Access Compliance Report

Public Rights-of-Way

(Curb Ramps)

Intersection ID: 10024552	Main Street: D_DUCKS_LN	Cross Street: N/A	Location: SE
ADA ID: DECEED0AB8ED	Ramp Type: PerpDiag	Initial Pass/Fail: Fail	Overall Compliance: No
Severity Score: 10			
Codes/Mitigation Info/Possible Solution		Field Measurements/Component Compliance

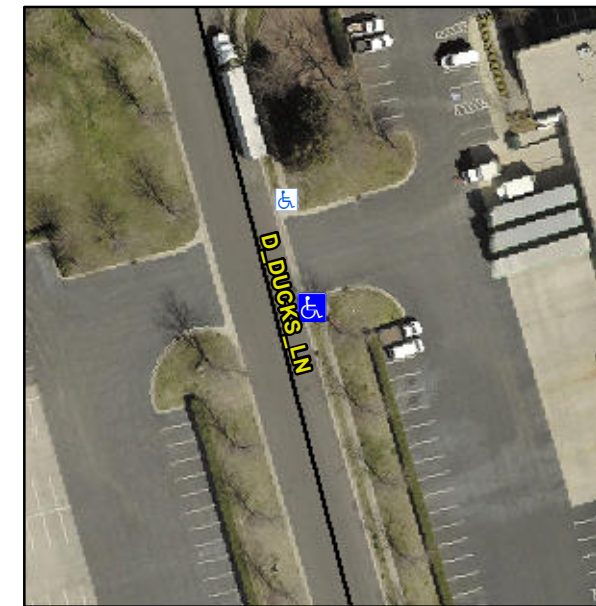
Not Found, R304.5.1, R304.5.3

Compliance	Description	Data	Compliance	Description	Data
N/A	Ramp Length (in)	38.0	Yes	Ramp Slope (%)	5.4
No	Ramp Width (in)	46.0	No	Ramp XSlope (%)	2.2
N/A	Flare Type LT	N/A	N/A	Flare Type RT	N/A
N/A	Flare Slope LT (%)	N/A	N/A	Flare Slope RT (%)	N/A
N/A	Flare Traversable LT?	N/A	N/A	Flare Traversable RT?	N/A
N/A	Landing Length (in)	N/A	N/A	DWS Provided?	N/A
N/A	Landing Width (in)	N/A	N/A	DWS Contrast?	N/A
N/A	Landing Slope (%)	N/A	N/A	DWS Length (in)	N/A
N/A	Landing X Slope (%)	N/A	N/A	DWS Full Width?	N/A
N/A	Landing Curb? (Y/N)	N/A	N/A	DWS Offset (in)	N/A
N/A	Shared Landing?	N/A			
N/A	Gutter Ponding?	N/A	N/A	Gutter Slope (%)	N/A
N/A	Gutter Lip Ht (in)	N/A	N/A	Gutter X Slope (%)	N/A
N/A	Painted X Walk1?	No	N/A	Painted X Walk2?	No
	X Walk 1 Direction	To N		X Walk 2 Direction	To W
N/A	X Walk 1 Width (in)	N/A	N/A	X Walk 2 Width (in)	N/A
	X Walk 1 Slope (%)	1.8		X Walk 2 Slope (%)	4.4
	X Walk 1 X Slope (%)	2.1		X Walk 2 X Slope (%)	1.6

N/A	Ramp inside XWalk1?	N/A	N/A	Ramp inside XWalk2?	N/A
	Road Slope (%)	3.0	N/A	Clear Space?	N/A
	Road X Slope (%)	8.4	N/A	Clear Space to XWalk (in)	N/A
N/A	Any Obstructions?	N/A	N/A	Storm Grate/Utility Hazard?	N/A
	Obstruction Type			Storm Grate/Utility Type	
		N/A			N/A
			Yes	Surface Condition? (G/P)	Good

Remove & Replace Curb Ramp With Two New Directional Ramps or Equivalent.
